TRIDENT TECHNICAL COLLEGE

Request for Quotation Amendment #: 1

DESCRIPTION: Fabricated Metal Aircraft Parts Boxes

ACM 210 Reciprocating engine overhaul
 engine disassembly box

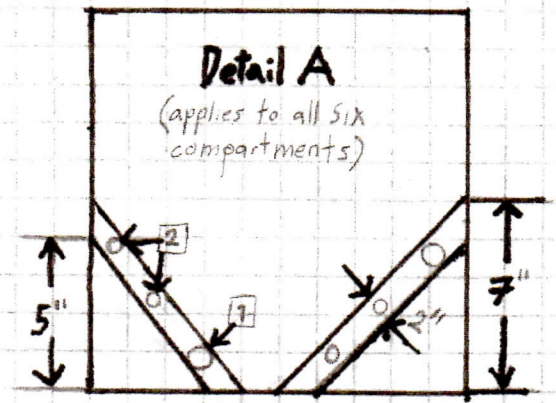
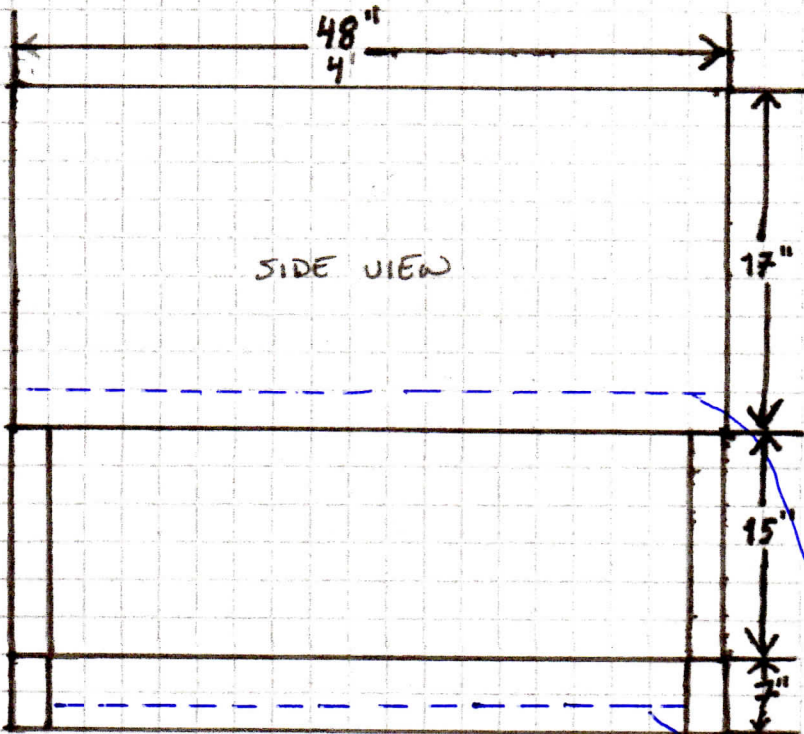
Q-3: What do the Teflon inserts look like?

Q-4: Are the angles welded flush to the top surface of Detail A?

A-3: TTC cannot provide a description. The Teflon insert is to protect the aircraft parts from damaging themselves or the box structure. The insert can be another chemical resistant material. In Detail A the 1" Ø and 2 "Ø holes should include the insert.

A-4: The angles shall be welded 2 inches from the top surface.

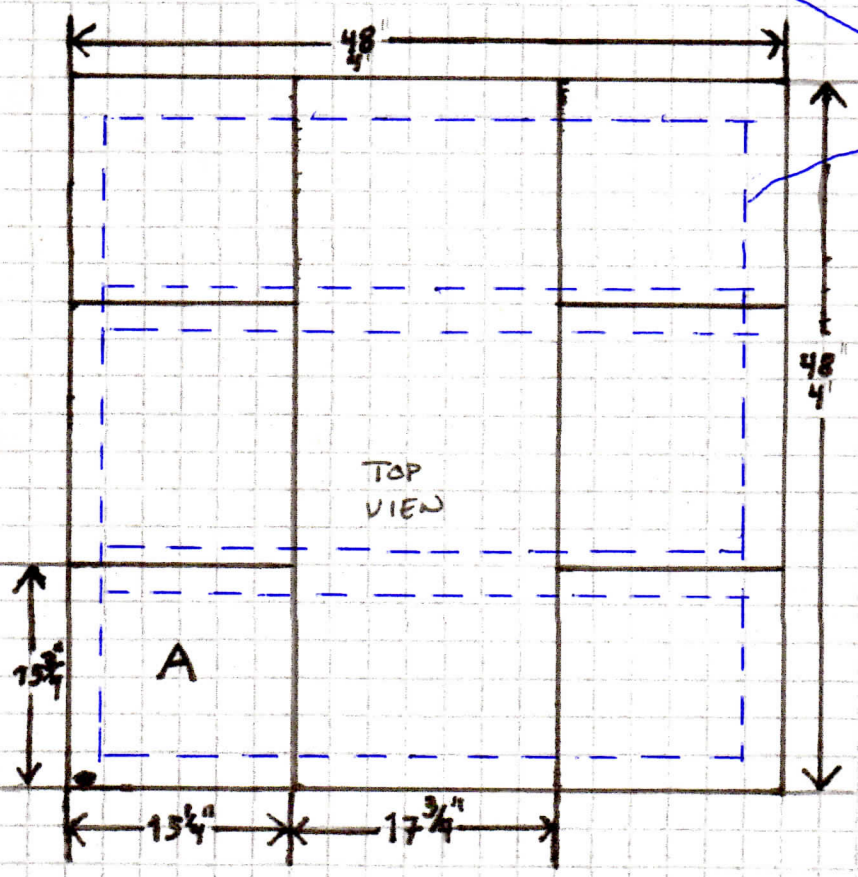
Q-5: A frame will be needed to support the top box and bottom shelf. Is the 17" and the 7" dimension inside or outside of the box?

- 1. large hole is 1 1/4" in diameter
- 2. small holes are 3/4" in diameter (TEFLON INSERTS)

Dotted Line
 Frame
 Tubing Frame
 1 1/2" TO SUPPORT

4 qty NEEDED

A-5: A frame will be needed. The 17" is a depth measurement from the top surface of the box. (inside or outside would not affect the measurement). The 7" is also a depth measurement for the bottom tray of the box. See attached revised drawing for reference only. Offerors shall submit a shop drawing with their submittal

- 1 1/2" ALUMINUM Sq Tube 1/8"
- 2" x 1/8" ALUMINUM ANGLE
- 1/8" ALUMINUM SHEET
- 4 CASTERS PER BOX
- BLUE POWDER COATED
